PRESENTATION SLIDES FOR JUNE 29, 2022 PRE-SUBMITTAL MEETING

**Callaway CSA LAR
Pre-Submittal Meeting**

- Welcome
- Meeting Purpose
 - Provide the NRC with information on the upcoming License Amendment Request (LAR) to reflect an updated Criticality Safety Analysis (CSA) for the storage of fuel in the spent fuel pool (SFP) at Callaway Energy Center
 - Obtain feedback from the NRC on the proposed LAR to ensure initial submittals address the full desired review scope and minimizes the need for RAIs
 - Mutual understanding of the proposed schedule and corresponding outage need date in order to ensure adequate NRC resource availability

Figure 3.7.17-1 Revision

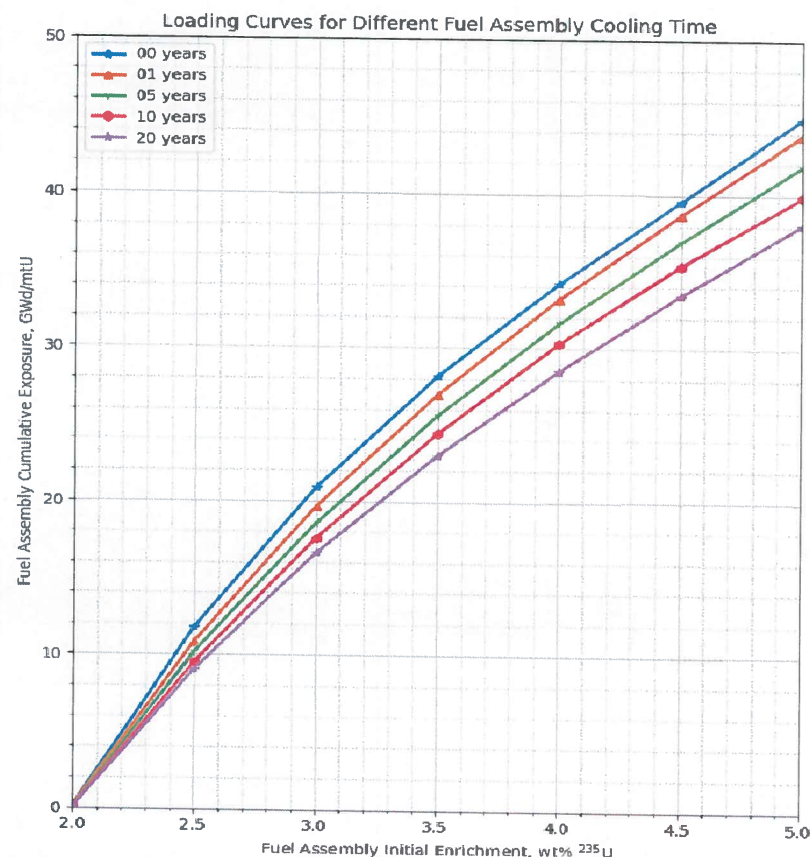
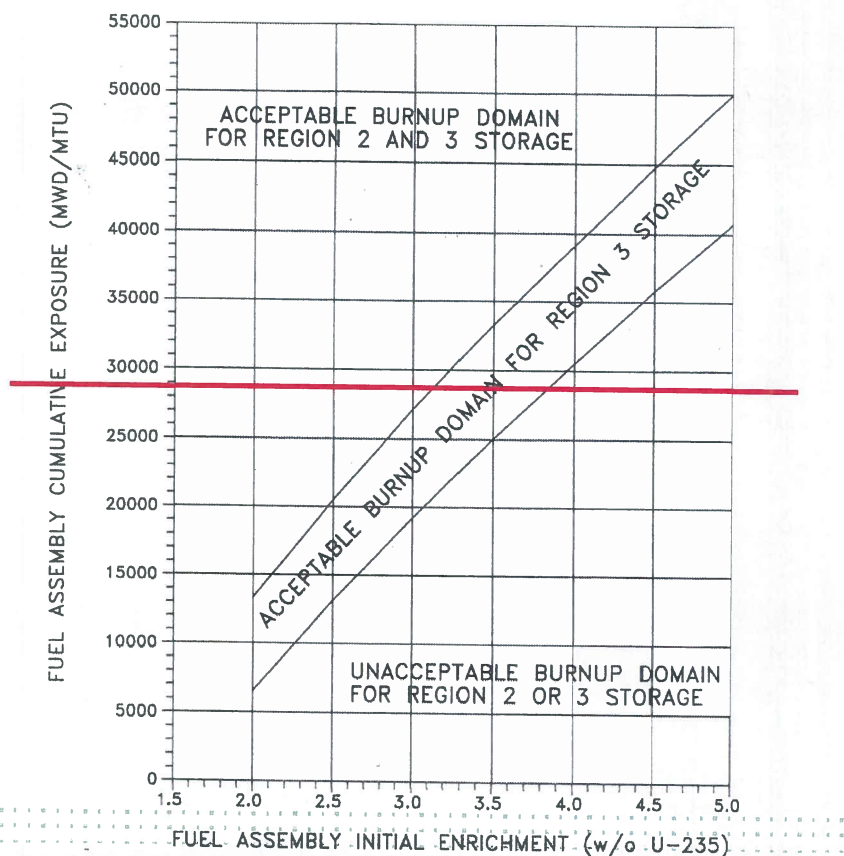
– Figure 3.7.17-1, “Minimum Required Fuel Assembly Burnup As a Function of Initial Enrichment to Permit Storage in Regions 2 ~~and 3~~,” will remove reference to Region 3 and reflect different loading curves based on Fuel Assembly Cooling Time
